June 24, 2024

To: Plan Holders for Improvements to the
KIRKSVILLE REGIONAL AIRPORT
KIRKSVILLE, MISSOURI
MODOT PROJECT NO. 24-028A-1

**ADDENDUM NO. 5
TO
CONTRACT DOCUMENTS, SPECIFICATIONS AND PLANS
FOR IMPROVEMENTS TO THE
KIRKSVILLE REGIONAL AIRPORT
KIRKSVILLE, MISSOURI
MODOT PROJECT NO. 24-028A-1**

EAS	EA2	6" METAL STUD AT 16" OC WITH 5/8" GWB ON BOTH SIDES WITH CONTINUOUS 6" SOUND ATTENUATION BATTS. EXTEND PARTITION AND SEAL TIGHT TO METAL DECK ABOVE. SEAL ALL OPENINGS AND PENETRATIONS. UL LISTING #: UL 465

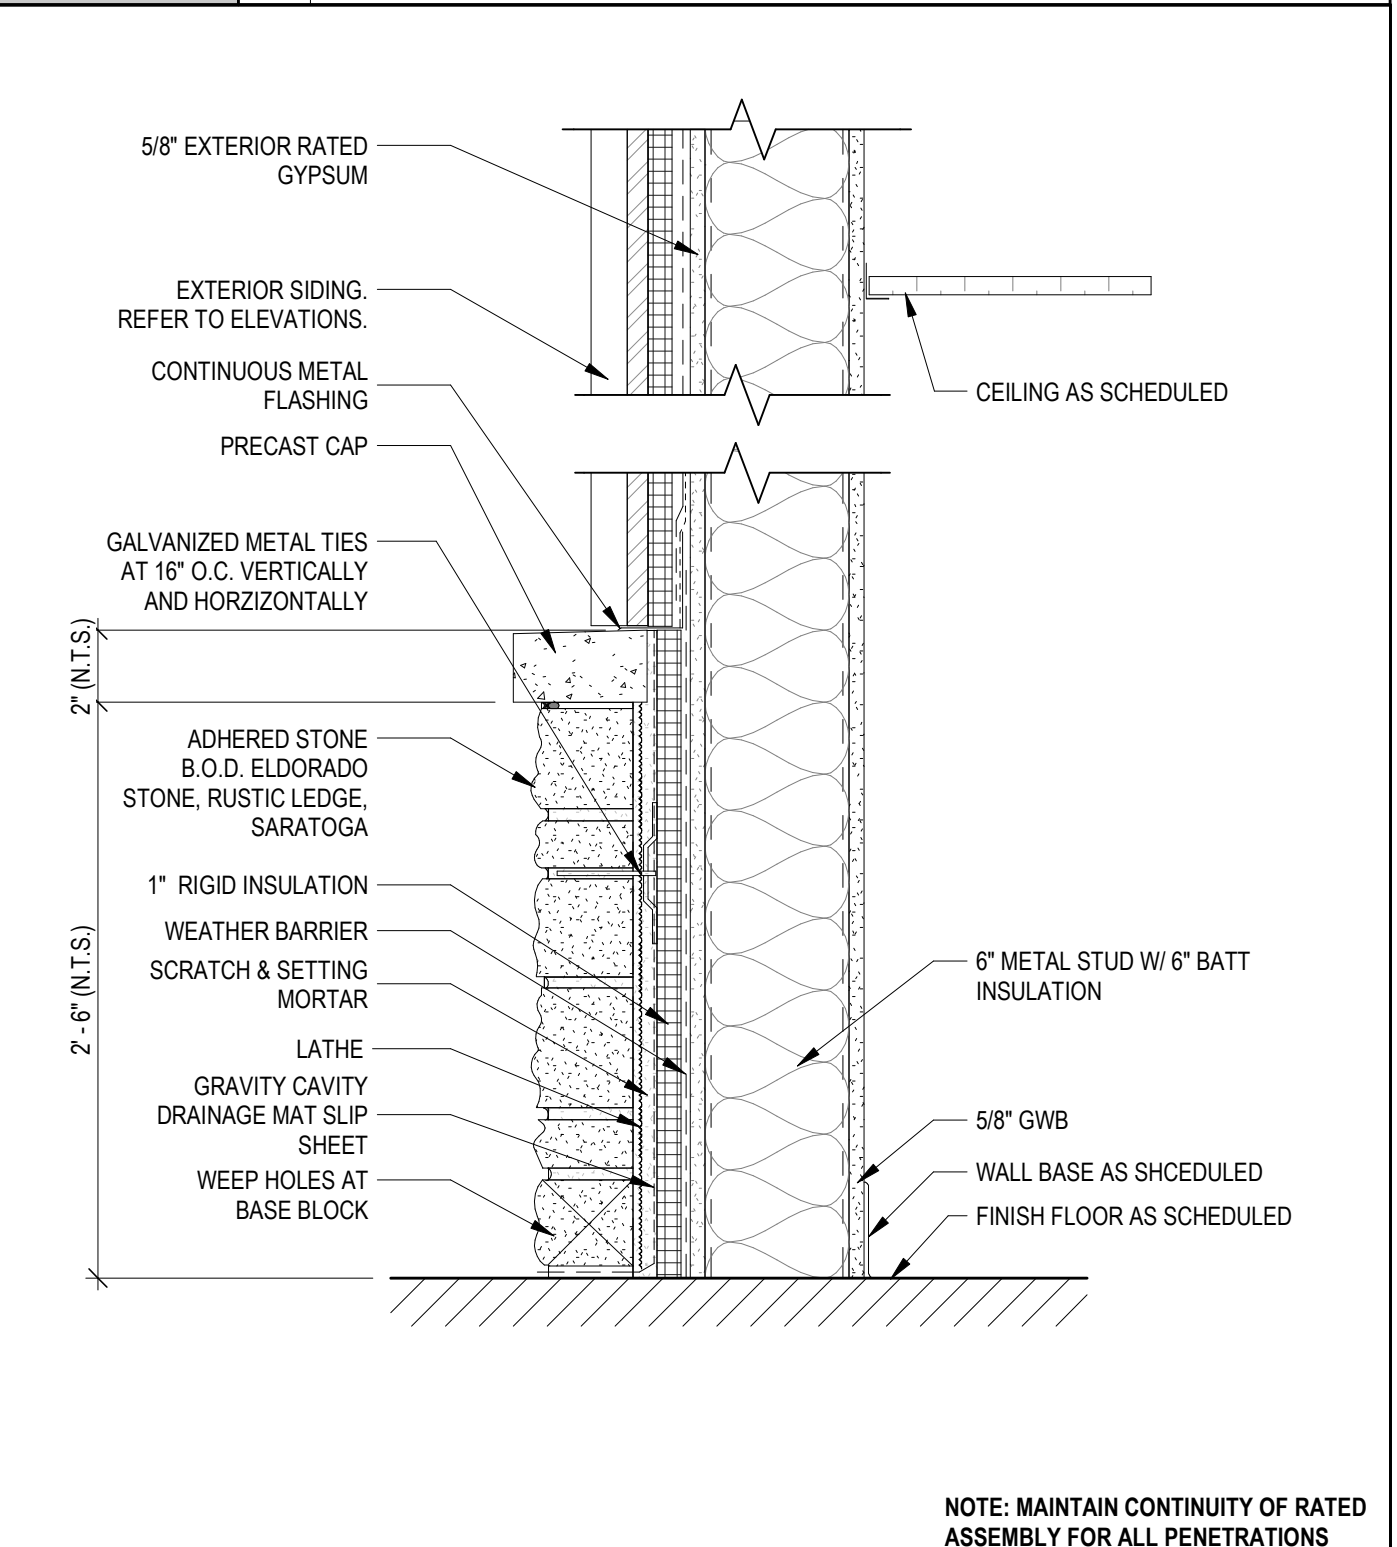
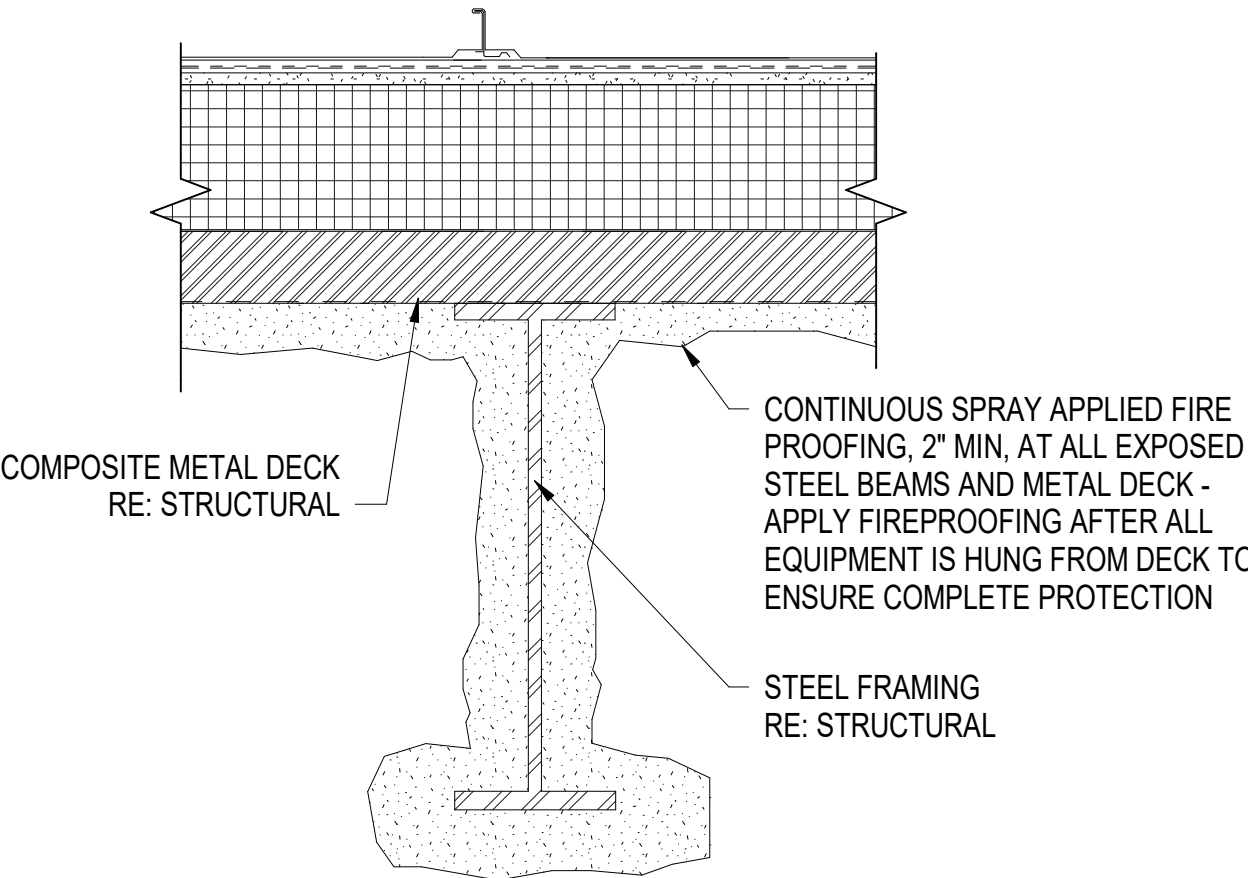
Sheet No.: A-002
Title: WALL AND ROOF/CEILING ASSEMBLIES
Revision: Revised Metal Roofing basis of design.
Justification: For clarity.

A-100

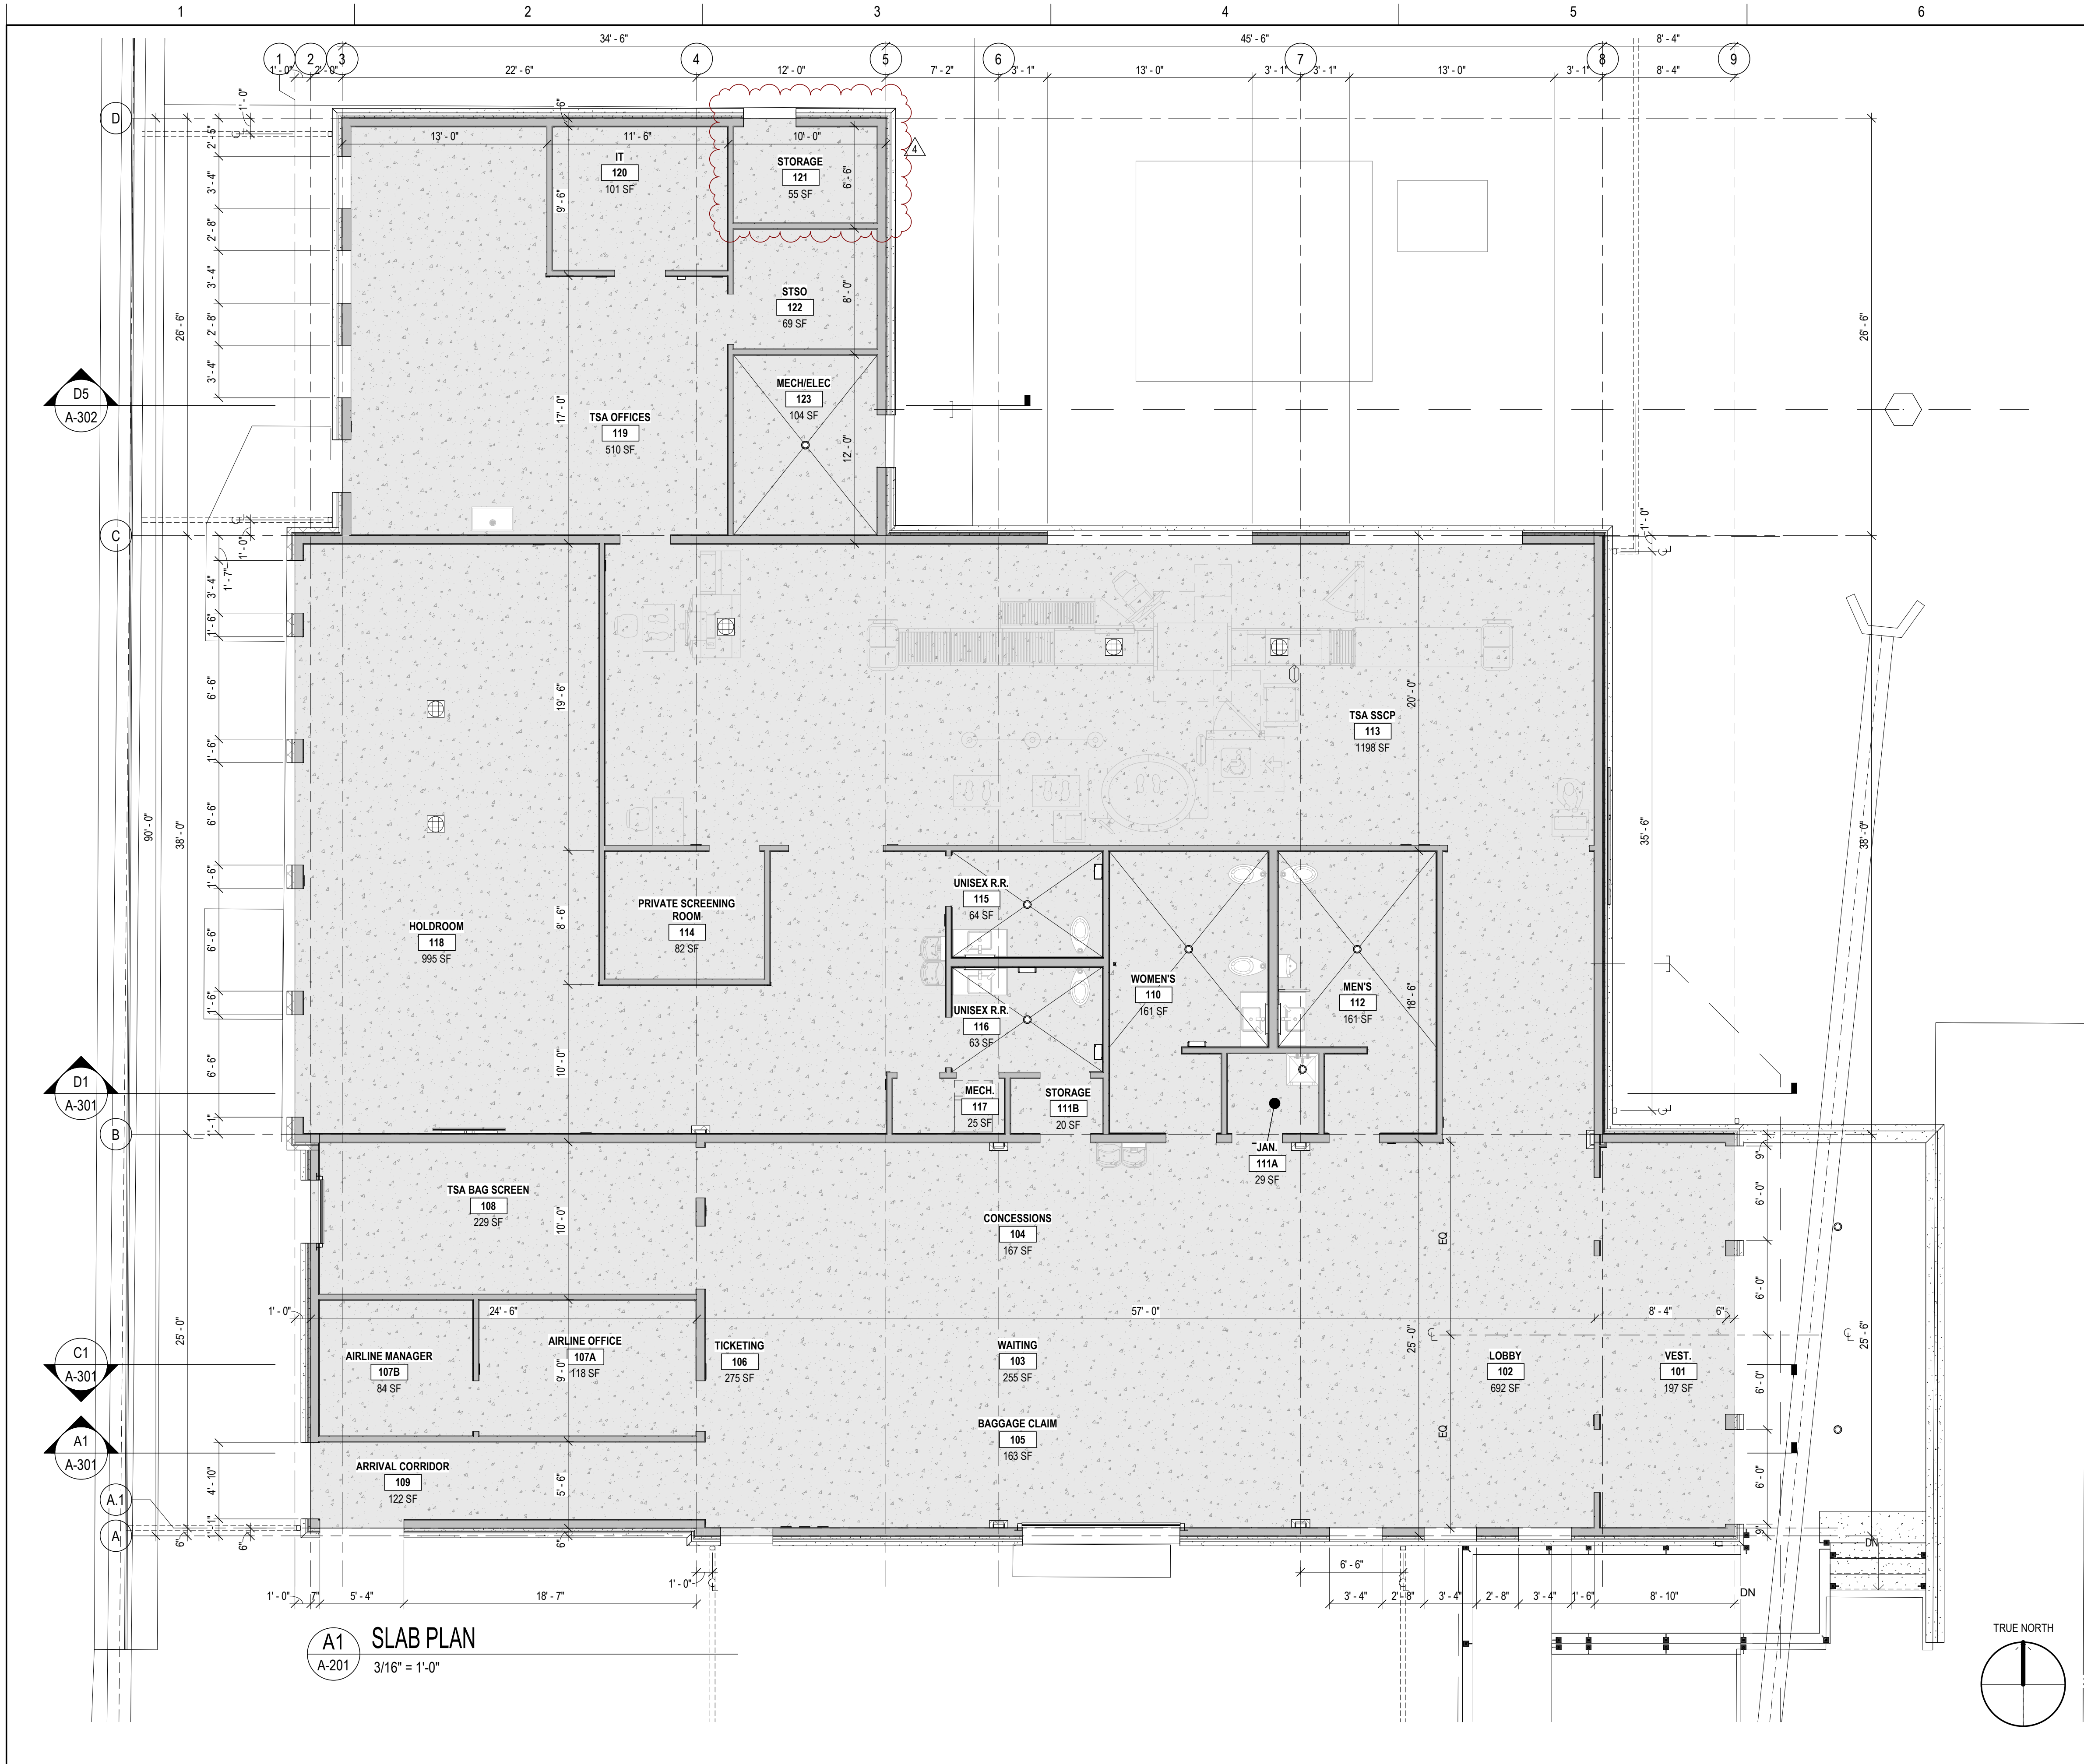
Sheet No.: A-100
Title: SLAB PLAN
Revision: Revised Door Location in Storage Room 121.
Justification: For clarity.

A-101

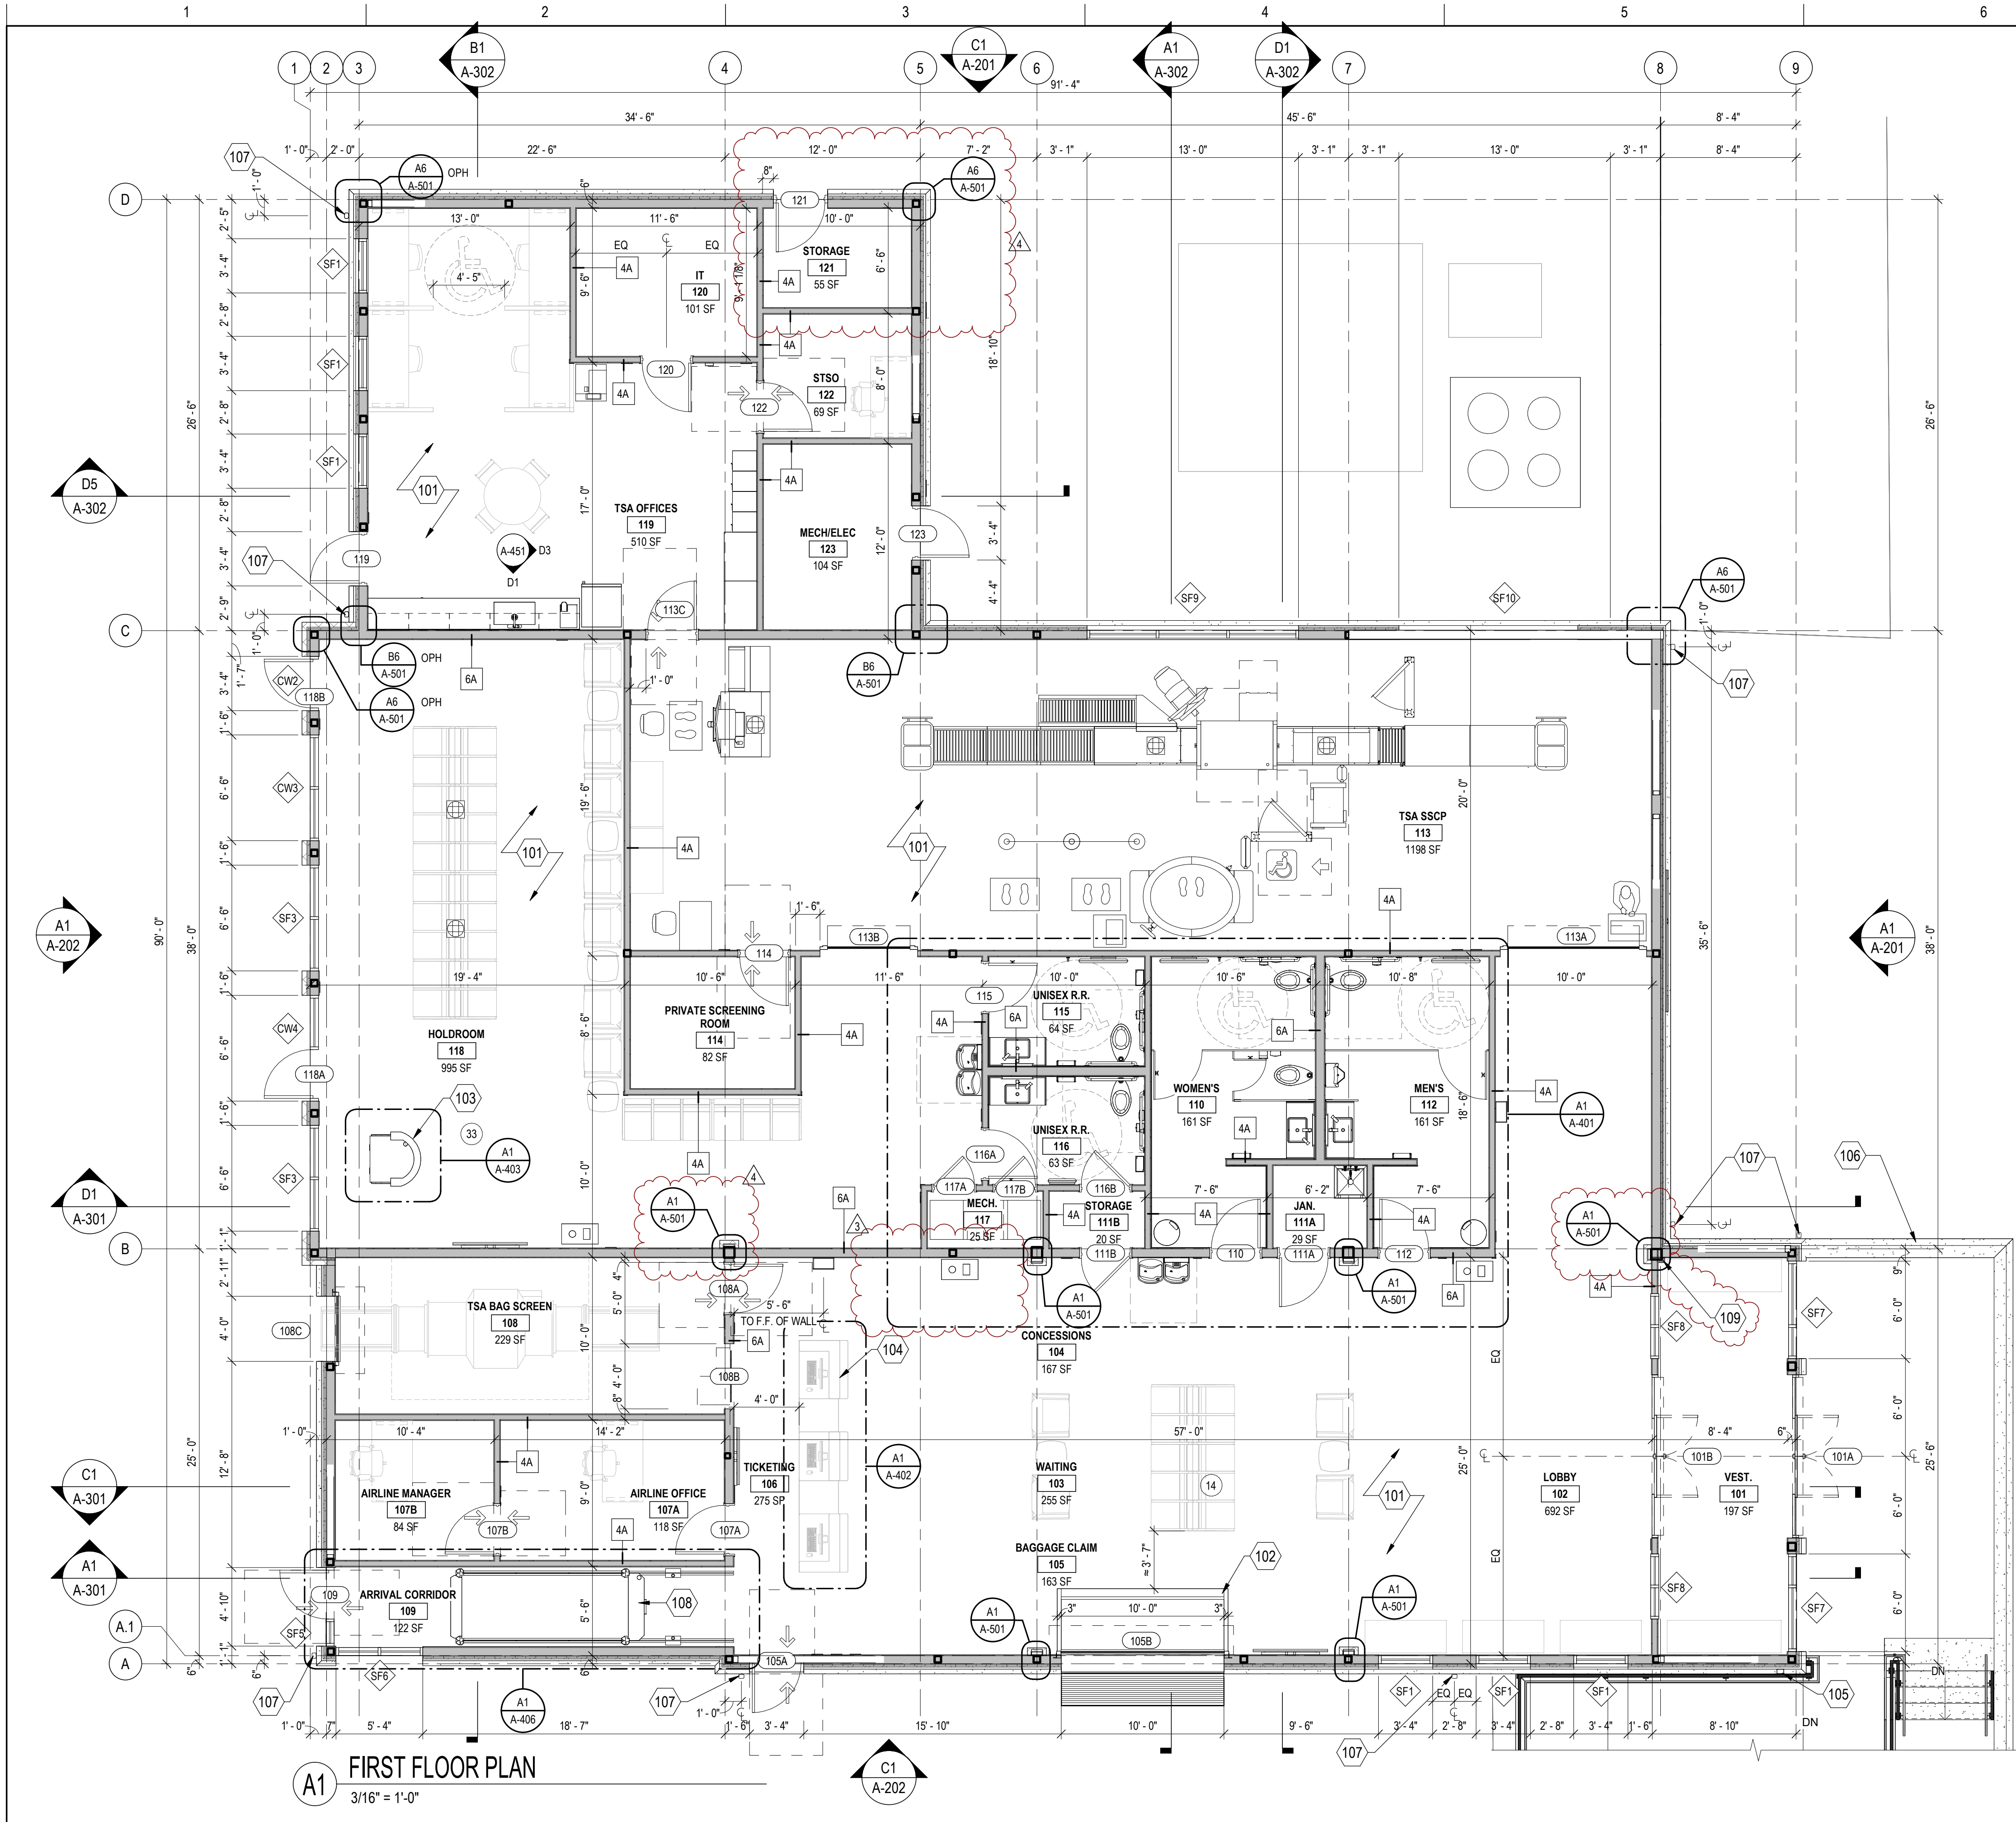
Sheet No.: A-101
Title: FIRST FLOOR PLAN
Revision: Revised Door Location in Storage Room 121. Added Column Stone wrap to column at GL B/4 and B/8. The GL B/8 detail will require a gyp board wrap on the east side of the column exposed to the Vestibule. Micro Market casework and details has been removed from project.
Justification: For clarity.
